RE: Re: Re: Re: DRMS Technical Revision 3 - Clarification

Re: <u>Pete Lien & Sons, Inc.</u>; <u>Mining Permit No. M-1977-002 HR; Munroe Gypsum; Technical Revision Request to formalize Affected Areas and increase the Total Disturbed Area at any one time. Clarification</u>

Permittee submits the following items for clarification based on the 15 November 2023 letter from Jocelyn Carter, Environmental Protection Specialist.

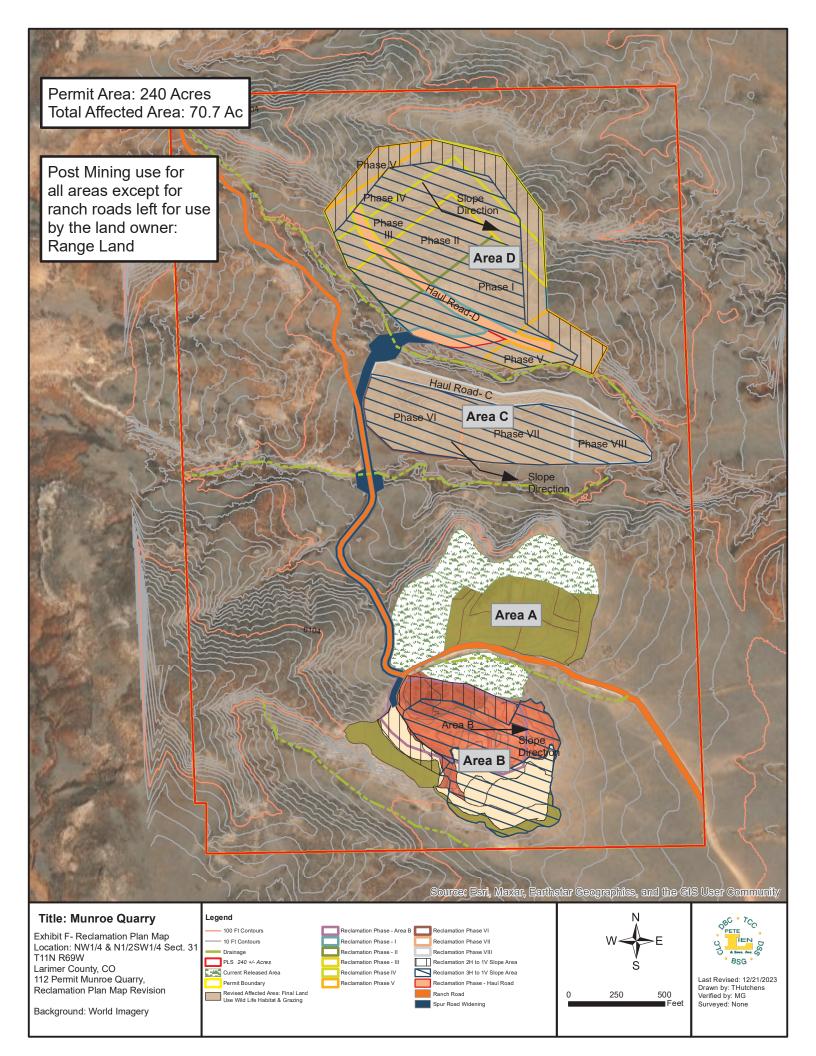
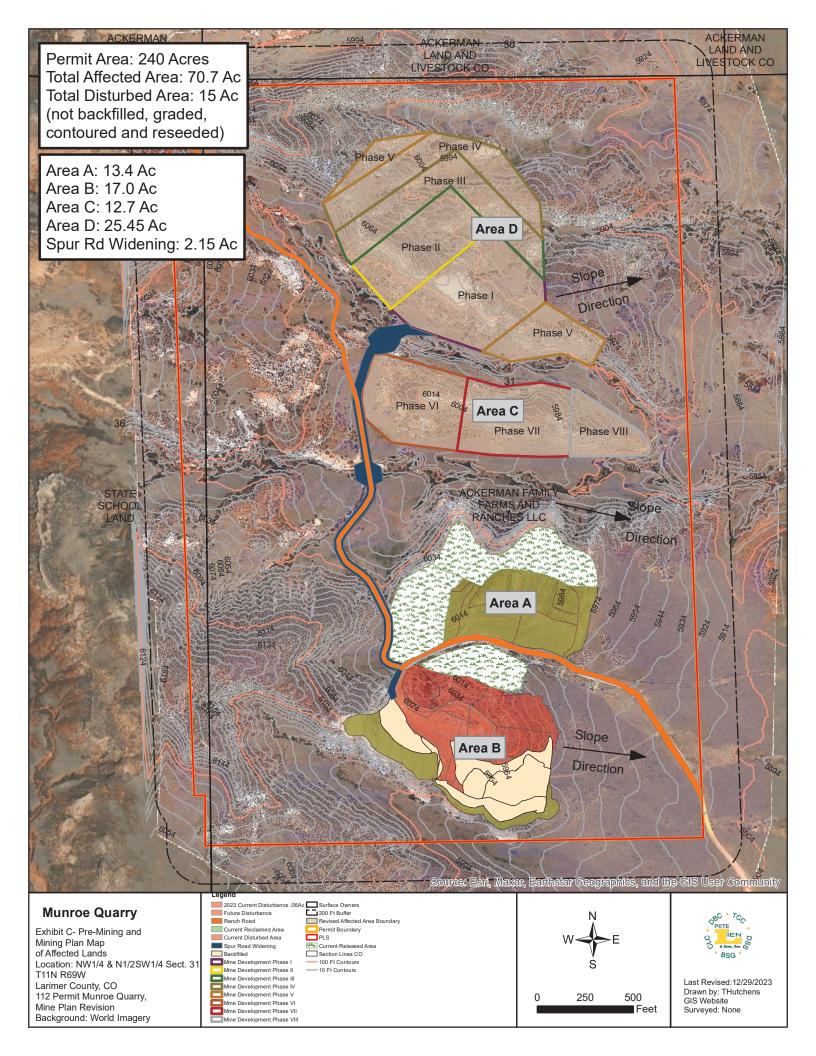
2) Revise map to indicate the name of the permittee, Colorado Lien Company, in accordance with Rule 6.2.1(2).

- 3) Revise Exhibit C map to include the following, in accordance with Rule 6.4.3:
 - a. All adjoining surface owners of record; per subparagraph (a)

c. Existing topography of the area with contour lines and the direction and rate of slope of the affected land; per subparagraph (c)

- 5) Revise Exhibit D to include the following information, in accordance with Rule 6.4.4(e):
 - a. Clearly outline how mining will progress in phases/sequence in the areas shown on the Exhibit C – Pre-mining and Mining Plan Map. Include a timetable narrative that reflects what is provided on the map into the written plan of Exhibit D, to include estimated periods of time for the various stages/phases; per sub-subparagraph (i) and (iii).

- b. Provide the acreage of the four mining areas shown on Exhibit C Pre-mining and Mine Plan Map, per sub-subparagraph (ii).
 - Acreage for each of the four mining areas has been added to Exhibit C.

The business name of Colorado Lien Company is now indicated on Exhibit C.

Eldon Ackerman, Ackerman Land and Livestock and Ackerman Family Farms are shown as adjoining surface owners.
 - b. Clearly identify existing "ranch road" and the "spur roads" that will be built on affected land; per subparagraph (b)

The Ranch Road and Spur Roads have been identified.

Contour lines and the direction of slope have been added to Exhibit C.

- Mining phases have been added to Exhibit C. Because of the inherent inconsistency of gypsum beds in this area, and future demand, it is not possible to provide definitive periods of time for each phase or stage. We believe that each mining phase will be active for 1-4 years.
